REGULATOR INFORMATION DISTRIBUTION SYSTEM (RIDS)

SUBJECT: Forwards responses to Round Two questions from Containment Sys Branch. Responses will be incorporated into FSAR amend. within 4 months. GE proprietary figures sent under separate cover by 810709 ltr.

Subject: SUPPLY SYSTEM NUCLEAR PROJECT NO. 23
RESPONSES TO ROUND TWO QUESTIONS
CONTAINMENT SYSTEMS BRANCH

FIGURE Q 022.061-1

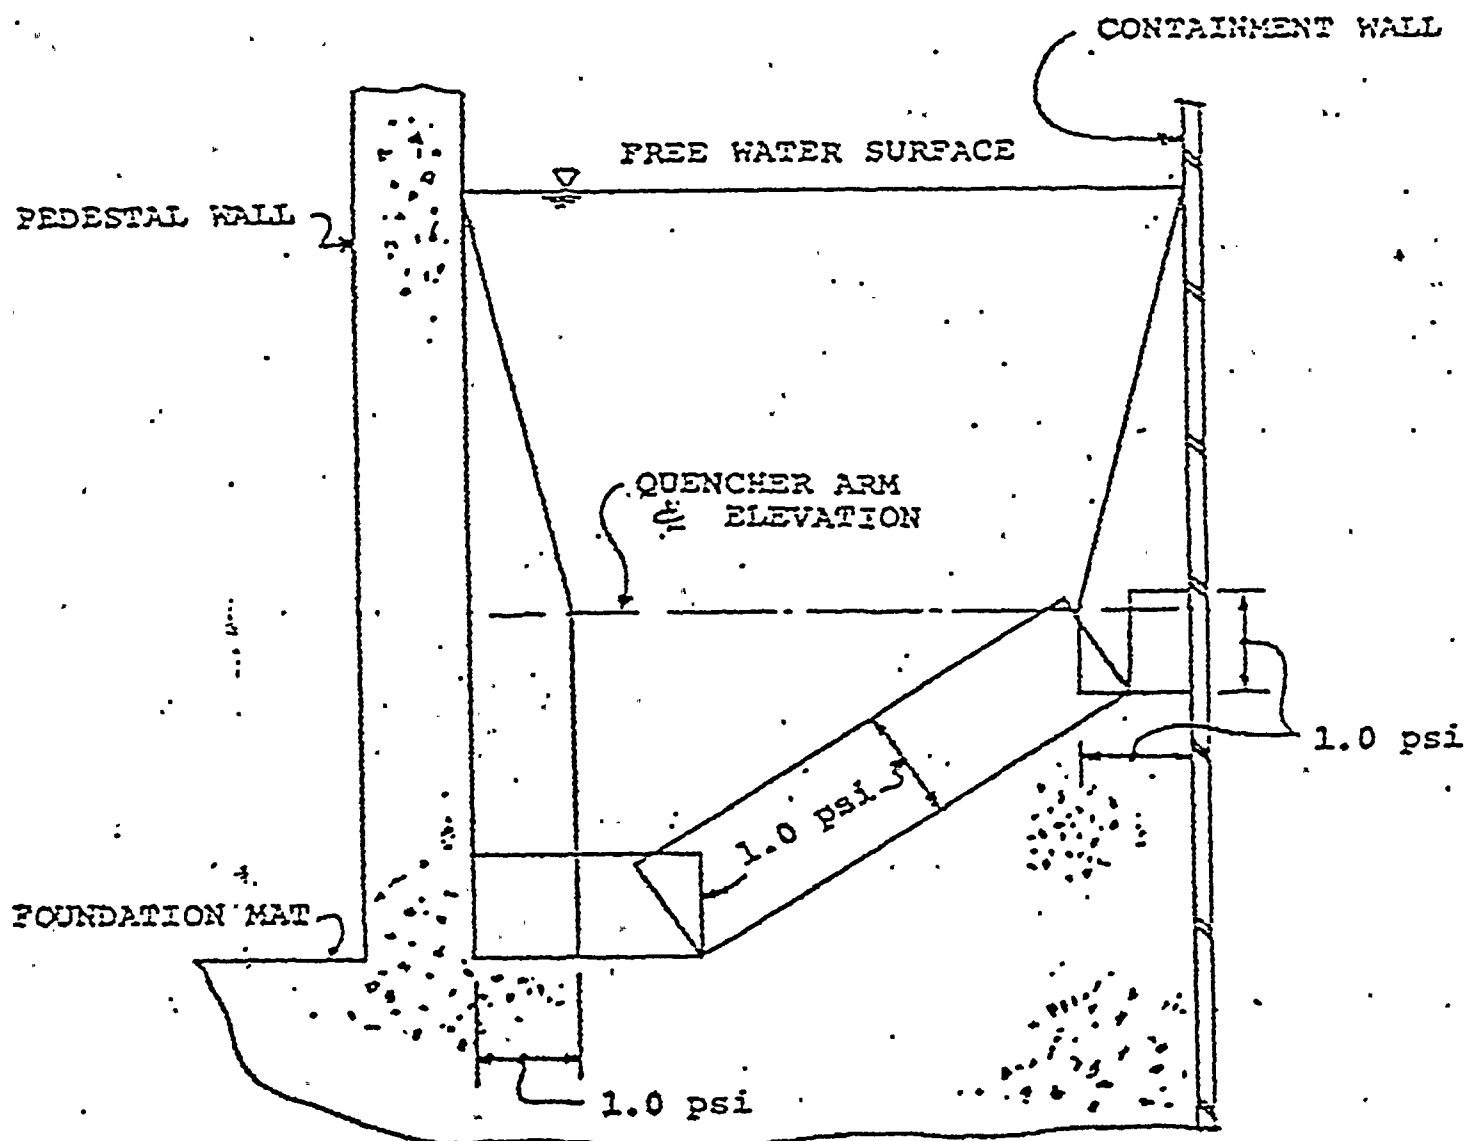
You use the methodology in the DFFR to establish the circumferential pressure distribution for the WNP-2 facility. State whether you use the line-of-sight and square-root-of-the-sum-of-the-squares (SRSS) assumptions of the DFFR in your calculations. If so, provide justification for using these assumptions in the WNP-2 facility. Your justification should be based on the Caorso test results. Indicate to what extent these assumptions affect the WNP-2 load cases. Provide representative figures showing the pressure distributions on the basemat, the pedestal wall and the containment wall for the various SRV discharge cases considered in WNP-2 plant design assessment.

Figures 022.061-1 and 022.061-2 illustrate the pressure distributions along the suppression pool floor and on the pedestal and containment walls for two SRV discharge cases, the all-valves case and single outer valve case. These two cases were determined to be the governing cases for the WNP-2 plant design, although the plant was also assessed for a single inner valve discharge case, a two valve discharge case and for the ADS case.

NOTE: FOR ALL VALVES CASE
CIRCUMFERENTIAL DISTRIBUTION IS CONSTANT

FIGURE Q 022.062-1

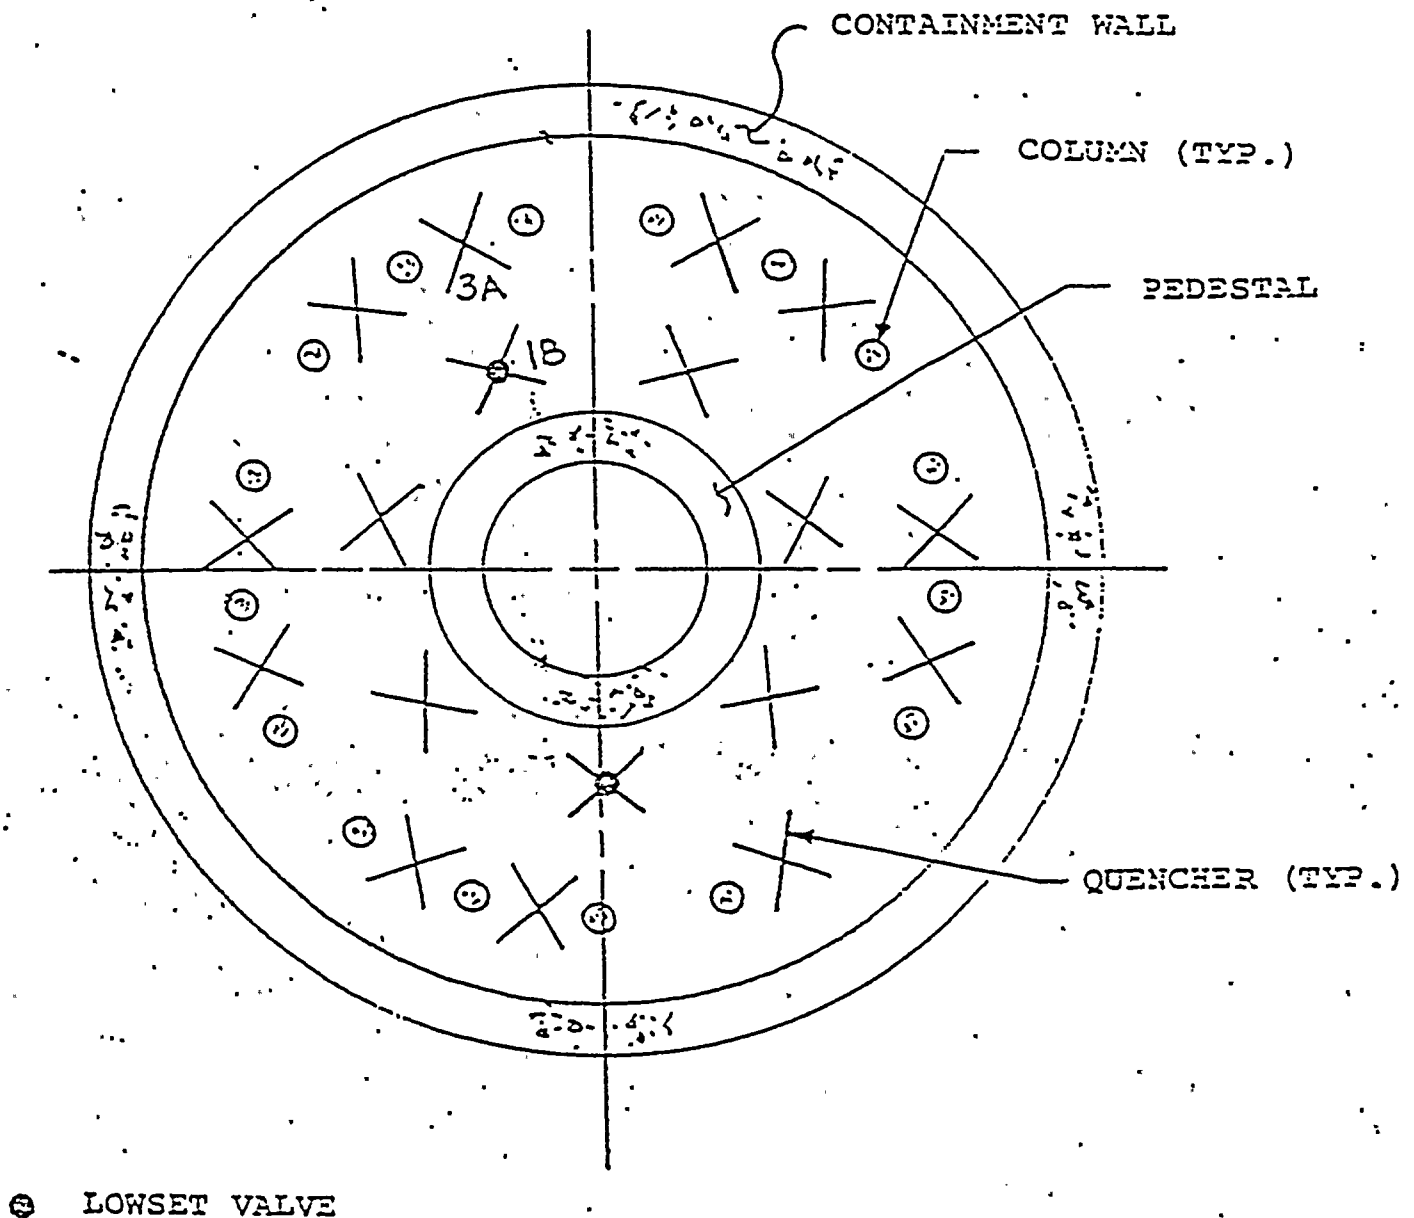
Indicate what two valves are selected for the two-valve discharge case. State whether the two quenchers selected are in the inner or the outer circle. Provide justification for the two valves selected and for their location.

The two valves selected for the two-valve discharge case are identified as 1-B and 3-A; one quencher lies in the inner circle while the other lies in the outer circle. There are a large number of cases to be considered, however, certain DFFR criteria limit this selection. One such criterion specifies that the required combination include one lowset valve and any adjacent valve. This statement limits the number of cases to be considered to seven. Of these seven tests analyzed, the arrangement chosen yields the most critical asymmetric loading condition thereby establishing the basis for the selection. Refer to Figure 022.062-1 for the location of the two selected quenchers.
